STA 167+50	STA 168+50
TOWN SEARSBURG-WILMINGTON	
PROJECT NHF NO. 010-1(18)	
SHEET 374 OF 435 SHEETS	
HORIZ. AND VERT. SCALE	
0 20	
SURVEYED BY: LANGILL	DATE 3-89

X35-B

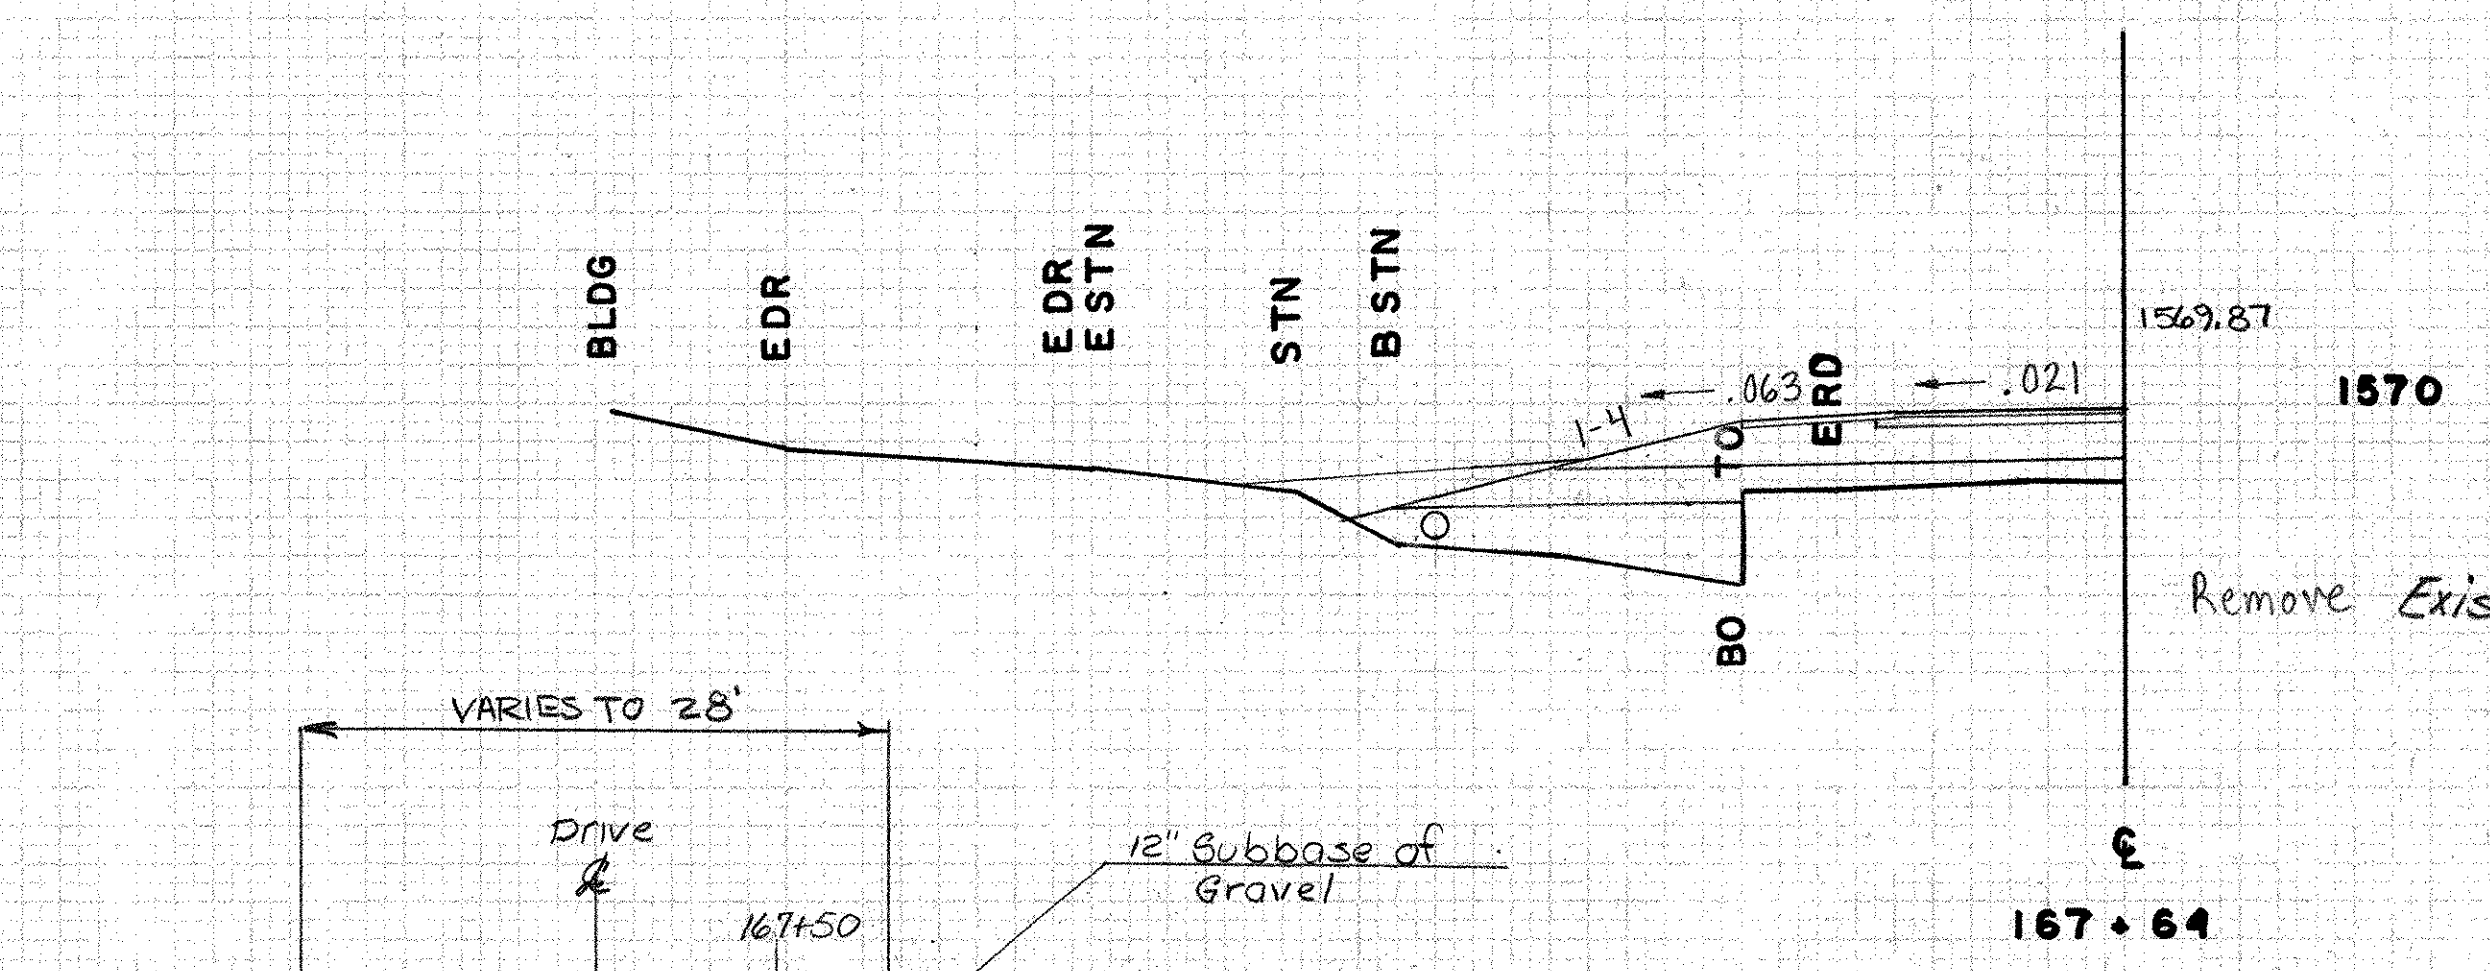
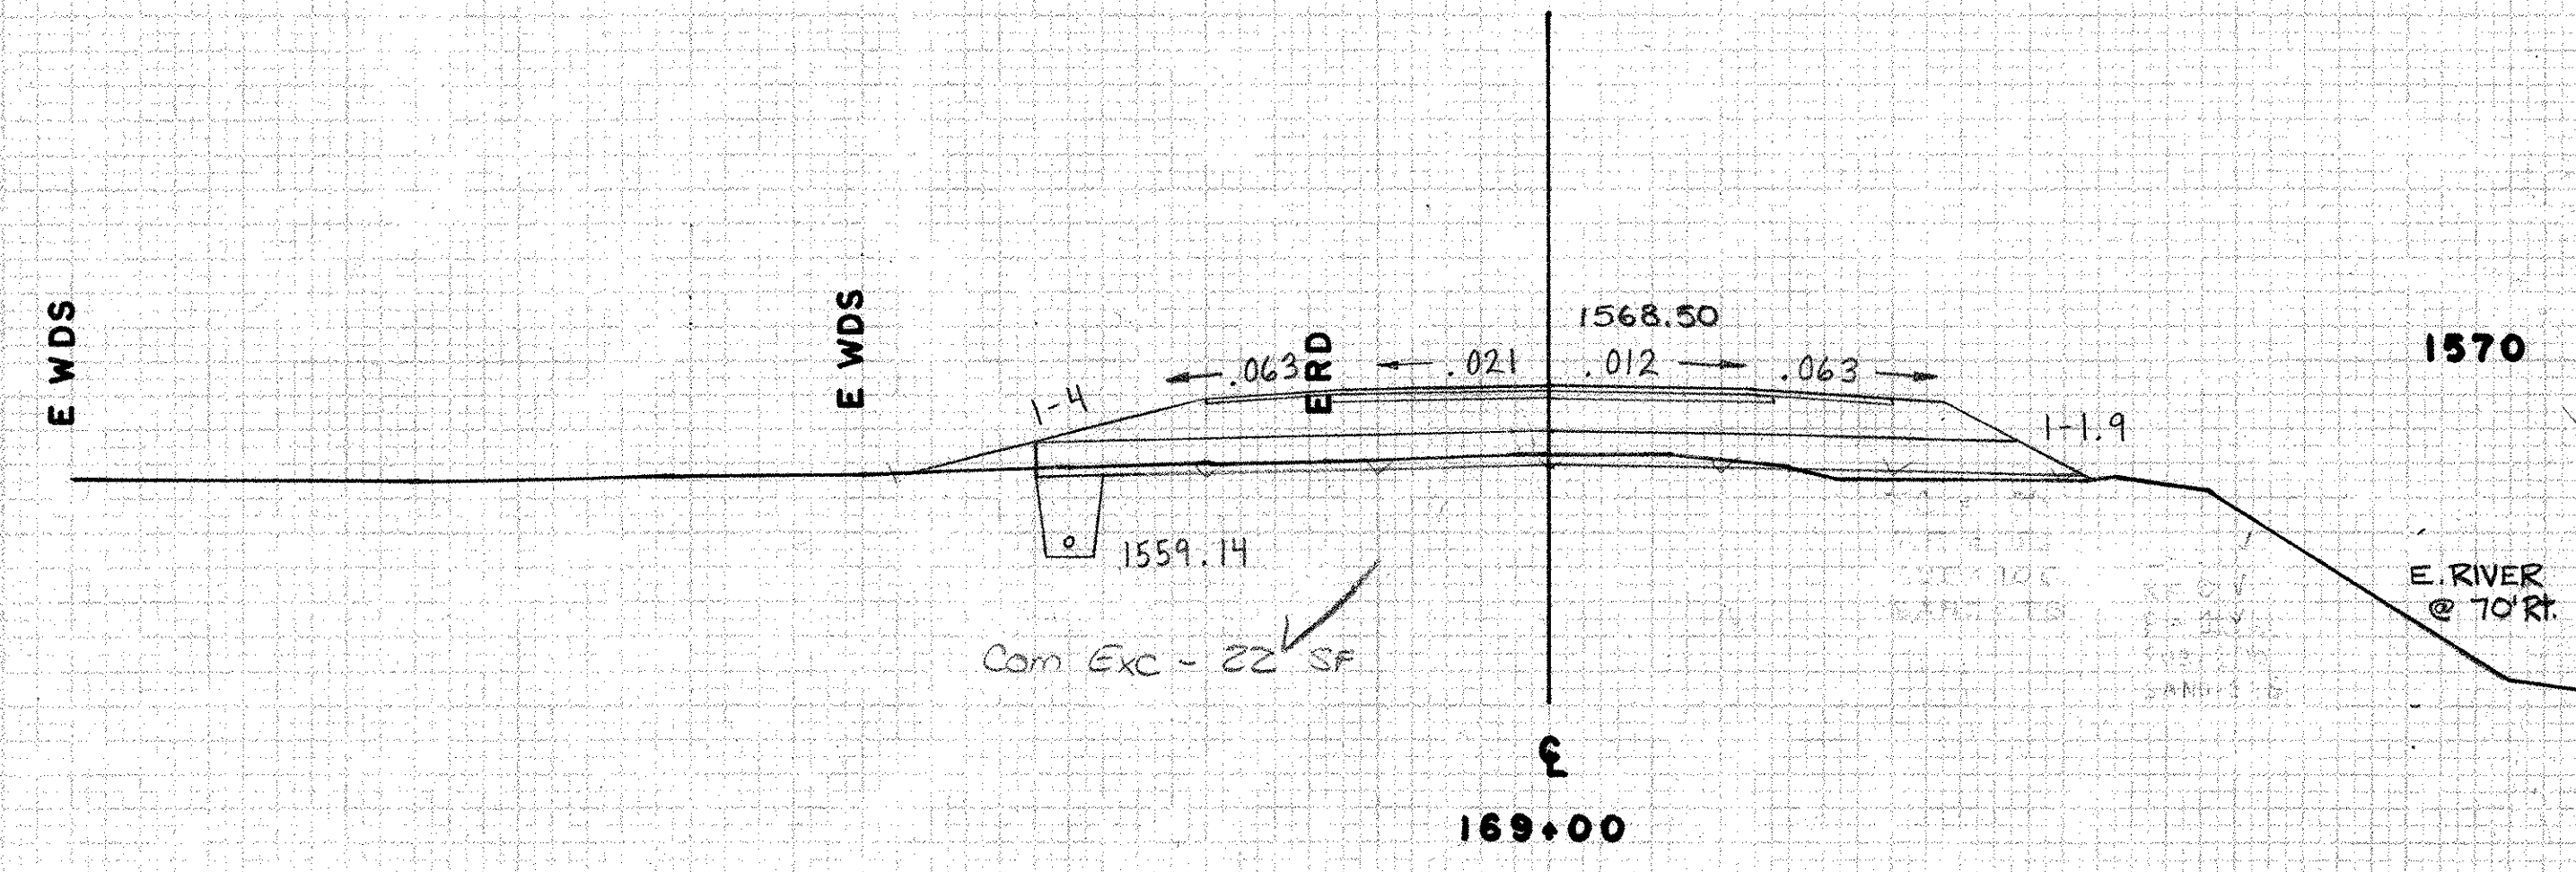
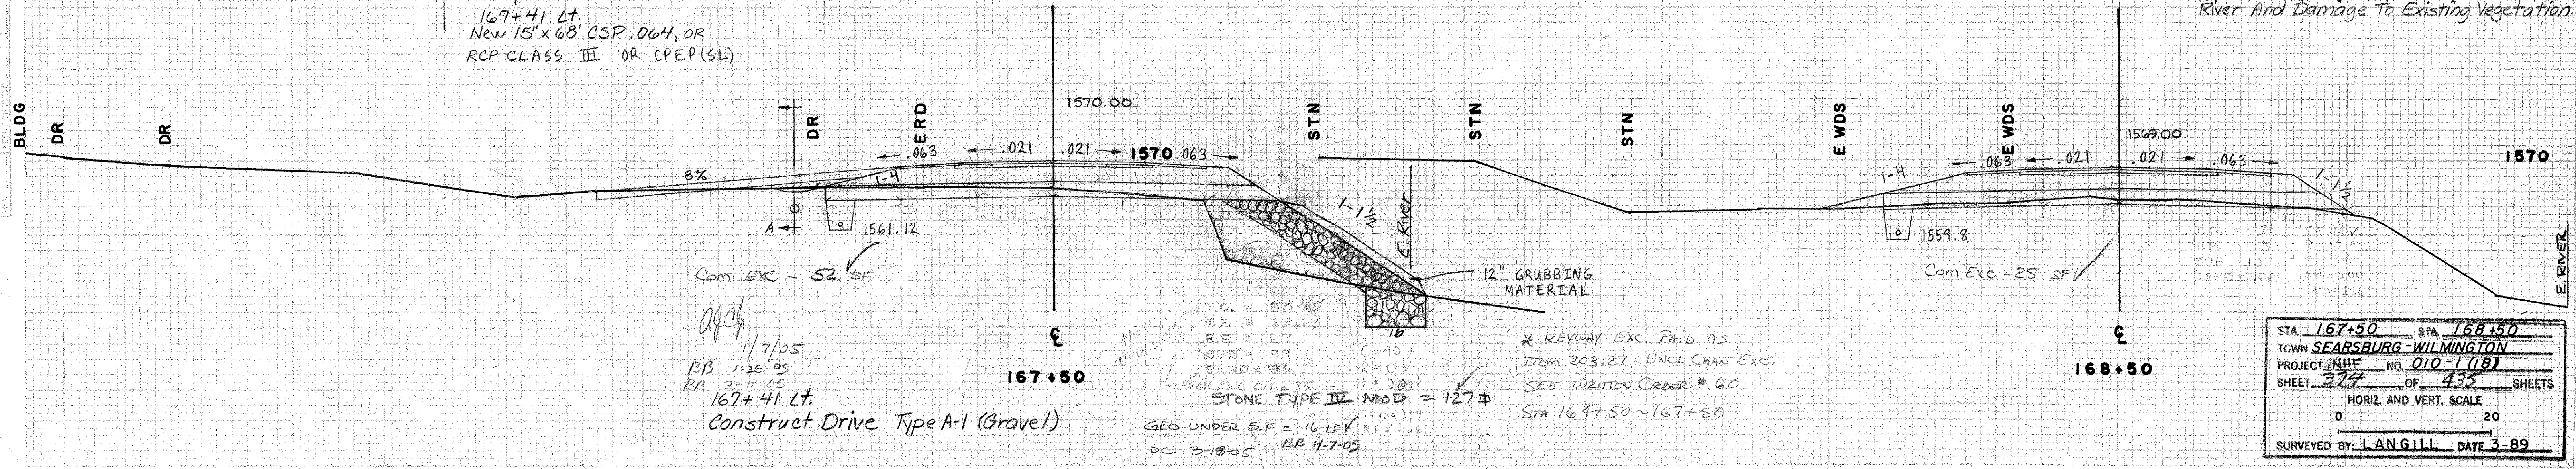
STONE TYPE II MOD = 127 #  
GEO UNDER S.F. = 16 LF  
DC 3-18-05

\* KEYWAY EXC. PAID AS  
ITEM 203, 27 - UNCL CAAN EXC.  
SEE WRITTEN ORDER # 60  
STA 164+50 ~ 167+50
